Reference: Engineering Services
88 Ashton Lane
Angier, NC 27501
TE&D Project No.: 2301-021018

As requested by the client, a representative of Tyndall Engineering & Design, PA (TE&D) was on-site to inspect and observe the following:

- 1) Analysis of existing covered porch ridge.

Ridge analyzed and recommendations per items 1a and 1b

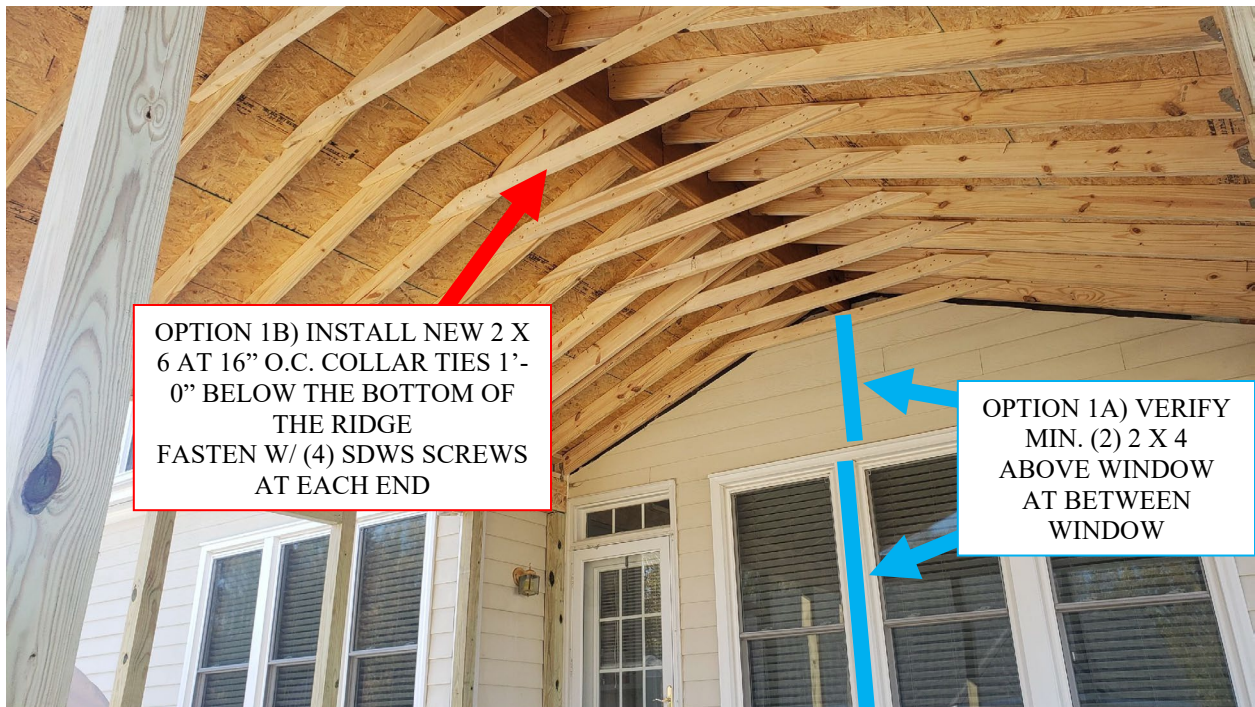
- 1) We observed the existing covered porch ridge as consisting of a (2) 1-3/4" x 11-7/8" LVL beam spanning front to back. The ridge was supported at the rear by a 4 x 4 post. We were unable to verify the method of bearing at the front (i.e. how it bears at the existing home). Based on our observations and analysis, the existing ridge will be adequate to support the anticipated loading conditions provided that (1) of the following modifications are made:

OPTION 1B) INSTALL NEW 2 X 6 AT 16" O.C. COLLAR TIES 1'-0" BELOW THE BOTTOM OF THE RIDGE FASTEN W/ (4) SDWS SCREWS AT EACH END

OPTION 1A) VERIFY MIN. (2) 2 X 4 ABOVE WINDOW AT BETWEEN WINDOW

- a. The ridge is to be verified as bearing on minimum (2) 2 x 4 jacks or 4 x 4 post at the front of the porch (i.e. the existing house). In addition, the existing (3) window opening is to be verified as having (2) 2 x 4 stud pockets to allow full transfer of loading to the existing foundation below.

- b. In lieu of option 1a, new 2 x 6 at 16" o.c. collar ties are to be installed positioned 1'-0" from the bottom of the ridge. Collar ties are to be fastened to the existing rafters with (4) SDWS screws at each end. The existing 2 x 4 collar ties with (6) nails at each end are inadequate to support the anticipated loading conditions.
